Access Compliance Report

Public Rights-of-Way

(Pedestrian Signals)

Intersection ID: N/A	Main Street:	Cross Street: N/A	Location: N/A
ADA ID: 3B3B0E3DC5FC	Signal Type: One Push Button-Non APS	Overall Compliance: No	Severity Score: BTN 1: N/A BTN 2: N/A No BTN: N/A
Codes/Mitigation Info/Possible Solution		Field Measurements/Component Compliance

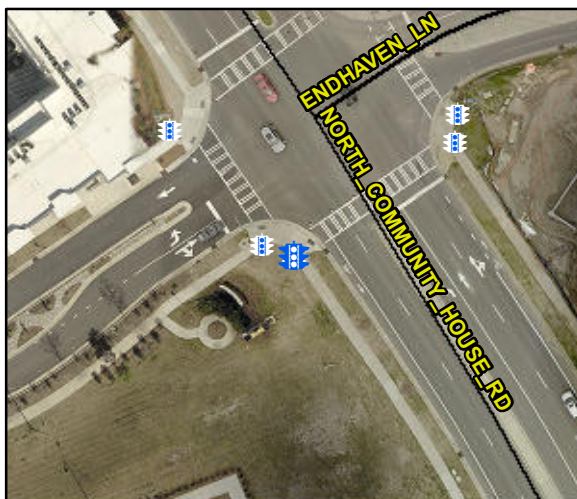
Surveyor Notes: N/A

PROW/ADA: TMUTCD 4e.08, R406.2

Possible Solutions: Replace Signal Push Button With APS Button on New Post. Remove & Relocate Sign.
